Subject: Notification of Class 1 Permit Modification to the Waste Isolation Pilot Plant  
Hazardous Waste Facility Permit Number: NM4890139088-TSDF

**Class 1 Permit Modification Notifications**

**Waste Isolation Pilot Plant**

**WIPP Permit Number - NM4890139088-TSDF**

**Figure D-5**  
**Underground Emergency Equipment Locations and Underground Evacuation Routes**

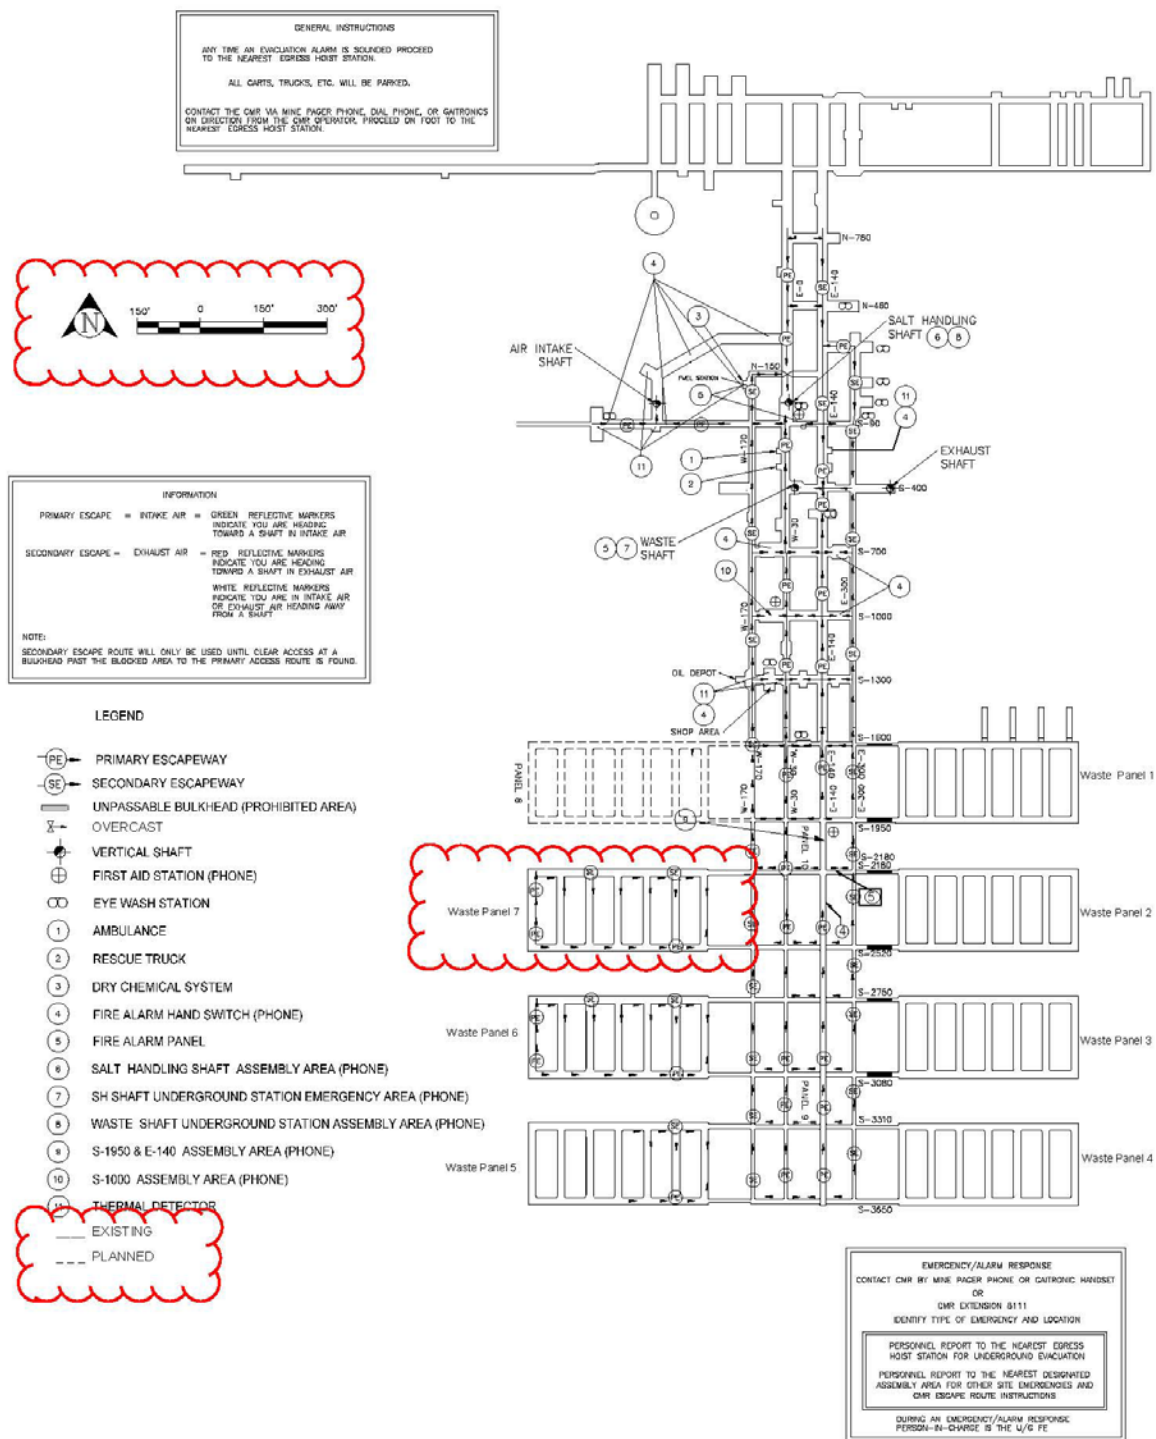
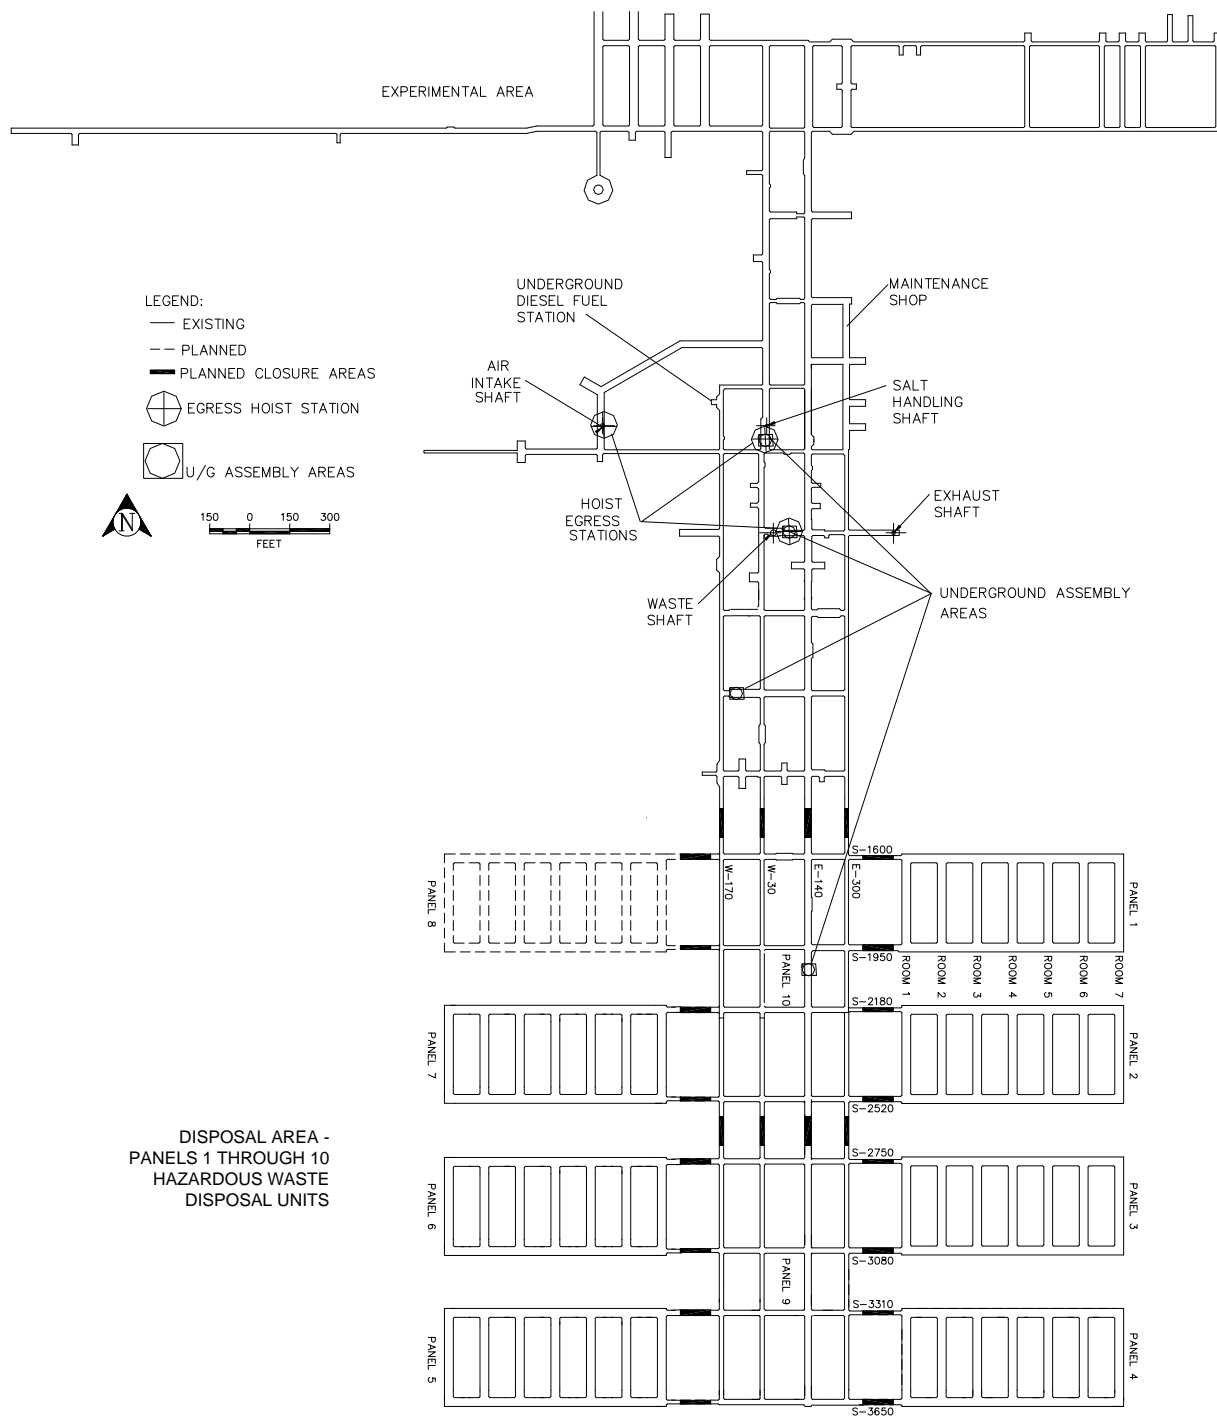
Attachment D, Figure D-3	Revised figure to indicate that Panel 7 has been approved for use.	A.1
	Attachment D, Figure D-5	Revised figure to indicate that Panel 7 has been approved for use. Added legend. Moved north arrow and scale to the top of the figure.	A.1
	Attachment D, Figure D-9	Revised figure to indicate that Panel 7 has been approved for use.	A.1
	Attachment G, Figure G-1	Revised figure to indicate that Panel 7 has been approved for use.	A.1
	Attachment G, Figure G-6	Revised figure to indicate that Panel 7 has been approved for use. Added marks for the H-16 and WIPP-19 boreholes. Moved the H-16 caption to the right.	A.1
	Attachment G2, Figure G2-1	Revised figure to indicate that Panel 7 has been approved for use.	A.1
	Attachment N, Figure N-1	Revised figure to indicate that Panel 7 has been approved for use. Added “existing” and “planned” to the legend. Added a scale and moved the north arrow. Added Panel 8 to the figure as “planned.”	A.1

On July 16, 2013, the Permittees were notified by the NMED that Panel 7 had been constructed in compliance with the requirements of the Permit. Panel 7 is now available for waste emplacement. Figures A2-1, A4-4, A4-4a, B3-2, D-3, D-5, D-9, G-1, G-6, G2-1 and N-1 have been revised to show that Panel 7 is now authorized for waste disposal. The change removes the “dashed” lines and replaces them with “solid” lines in order to change the designation from “planned” HWDU to “existing” HWDU.

**Figure G-1**  
**Location of Underground HWDUs and Anticipated Closure Locations**

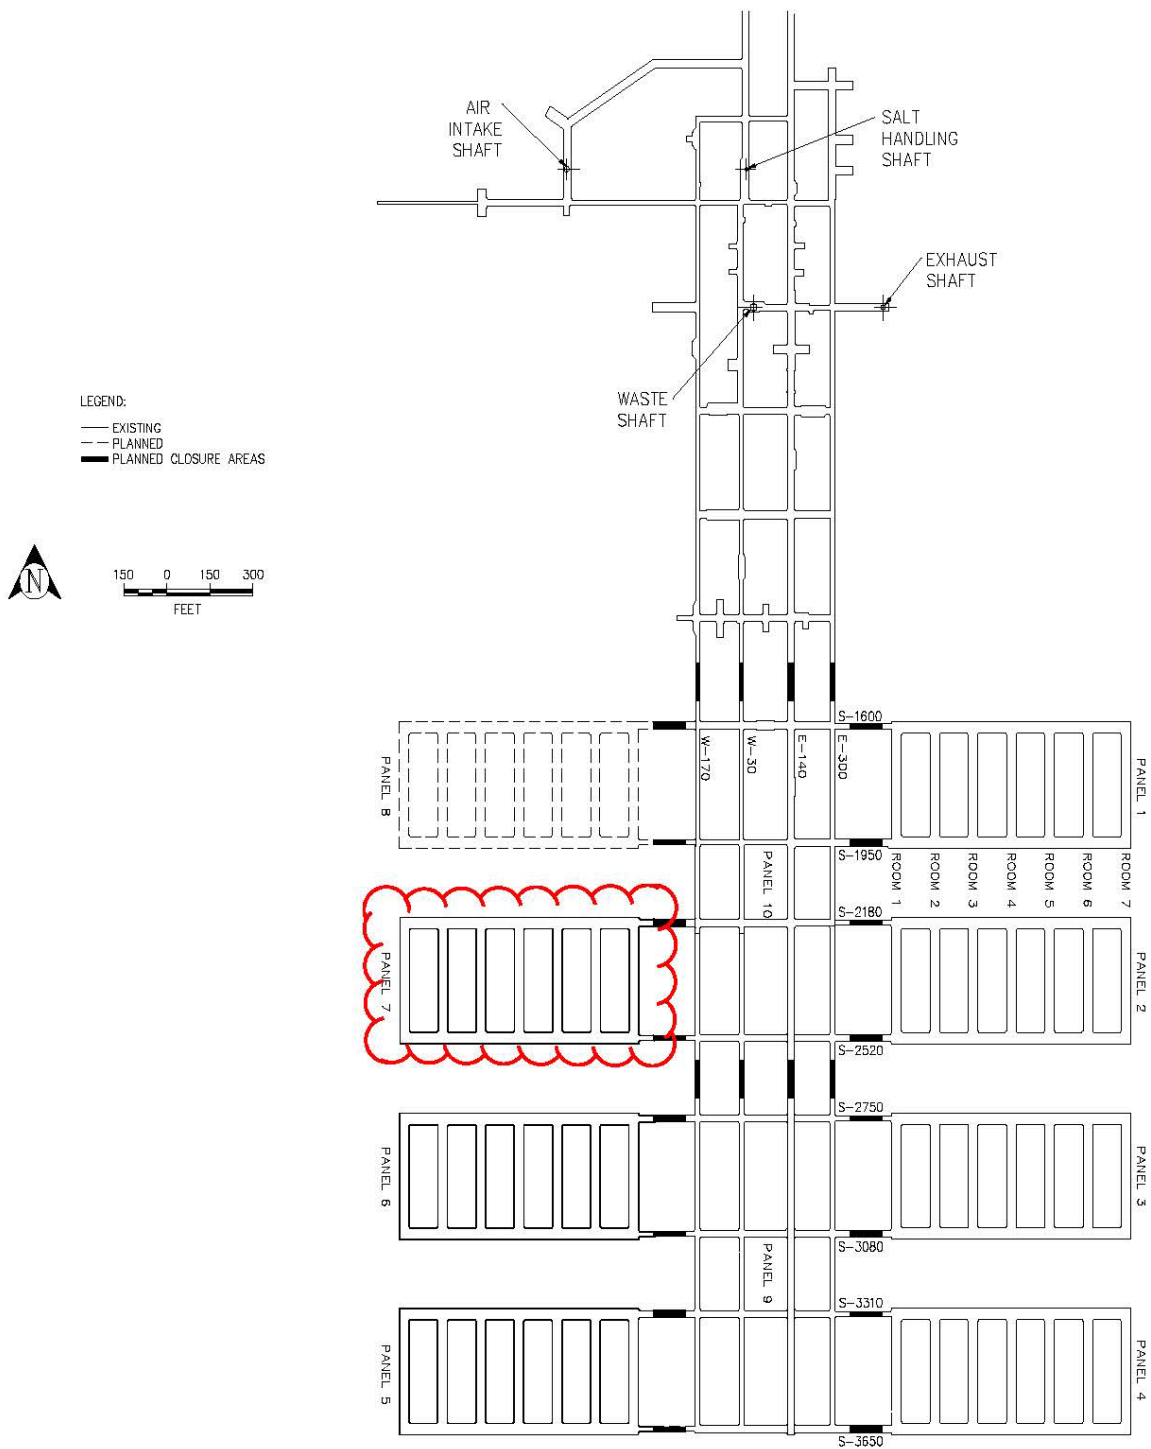
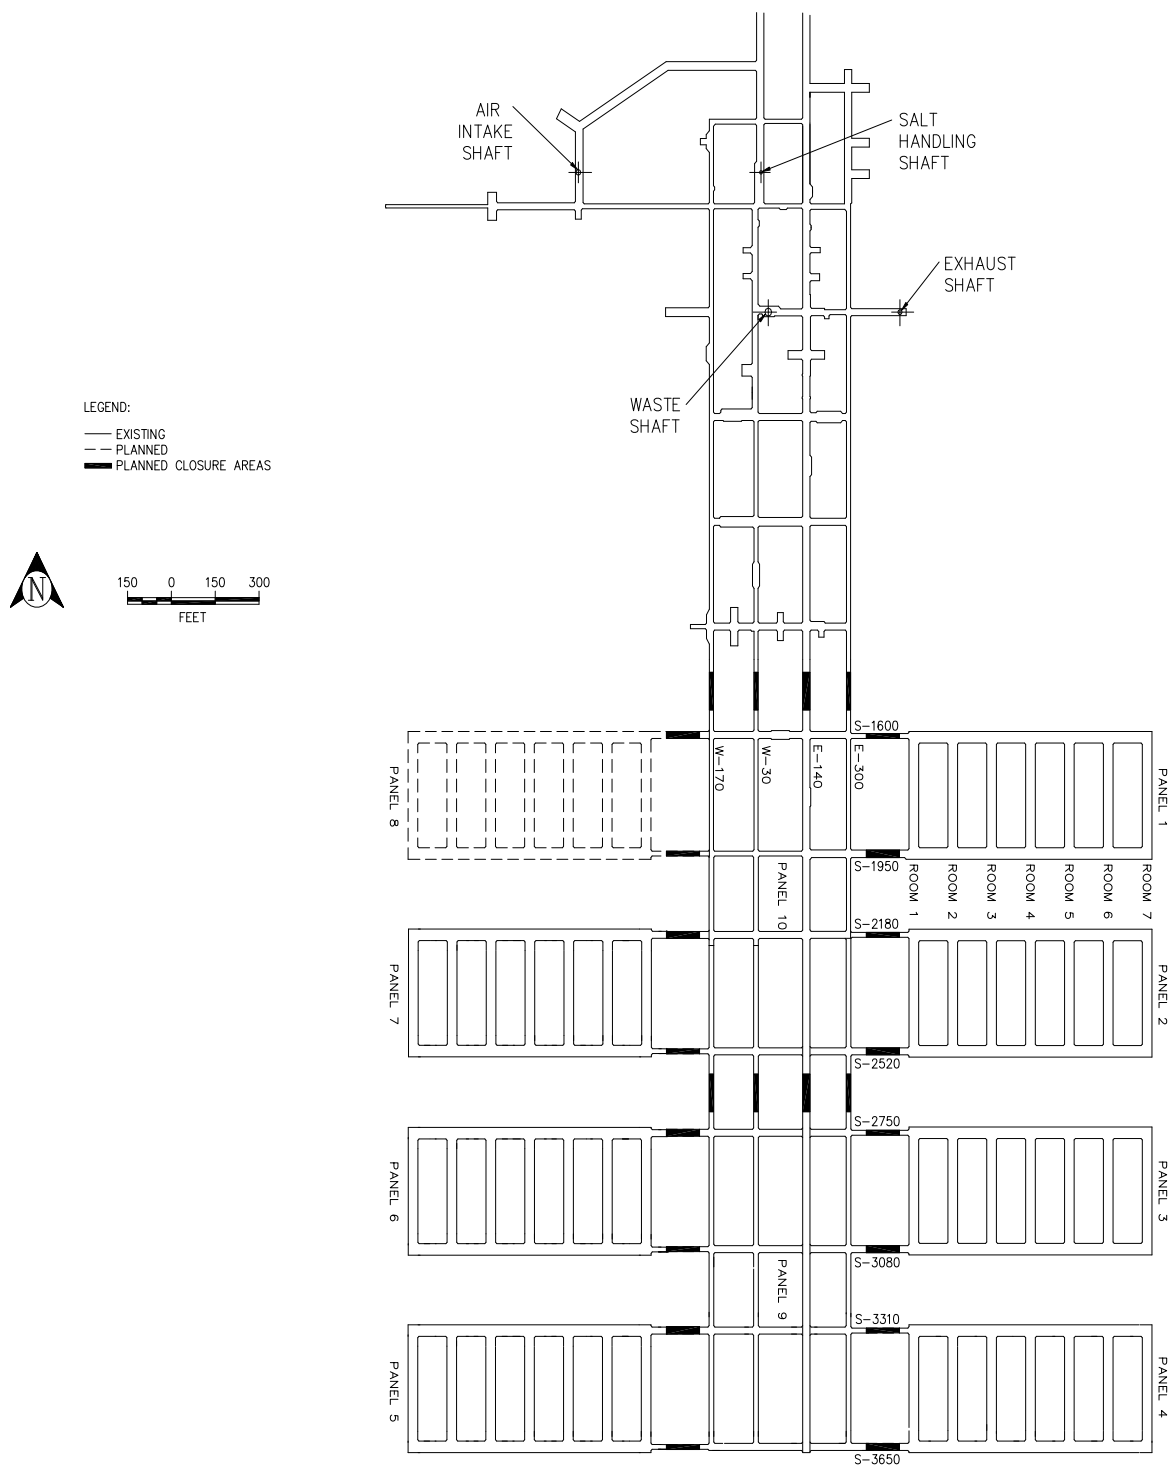
This modification revises Permit Attachment K, Table K-4 and Permit figures A2-1, A4-4, A4-4a, B3-2, D-3, D-5, D-9, G-1, G-6, G2-1, and N-1 to indicate that Panel 7 has been approved by the NMED. The text “SWMU 013i Underground HWDU – Panel 7” is being added to Attachment K, Table K-4. The figures were updated by changing Panel 7 status from “planned” to “existing” hazardous waste disposal unit (HWDU). This is done by changing dashed lines to solid lines or by adding Panel 7 to respective figures. Additional editorial changes were made to some figures which included the following: added legend, north arrow, and scale to Figures A4-4 and A4-4a; added Panel legend (for existing and planned Panels) and moved north arrow and scale to top of Figure D-5; added borehole markers for boreholes H-16 and WIPP-19 and moved H-16 borehole caption to the right on Figure G-6. Also see the Table of Changes and the “clouded” figures in Appendix C of this PMN for a description of these changes.
